Subject: Re: Methyl mercury monitoring for Southeast Connector

Subject: Methyl mercury monitoring for Southeast Connector

The locations are here:

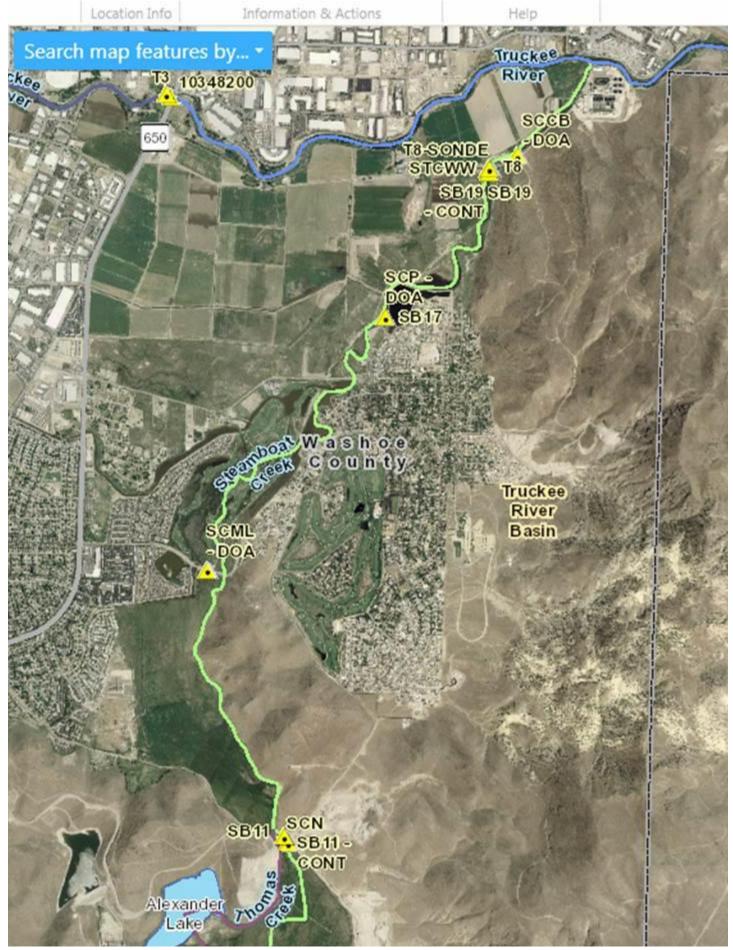
One gap I'm seeing is that there is no sampling at the outlet to the Truckee River, but there is sampling downstream of all of the constructed wetlands, so that may be enough.

The idea of having NDEP incorporate the potential impacts of the wetland construction into their existing monitoring network sounds good. Sounds like they currently have 14 locations they sample? In terms of measuring low level Hg/MeHg, may be able to significantly economize on the number of locations where these parameters were specifically measured...a handful upstream of downstream of the proposed wetlands would probably be sufficient to meet this additional projects objectives.
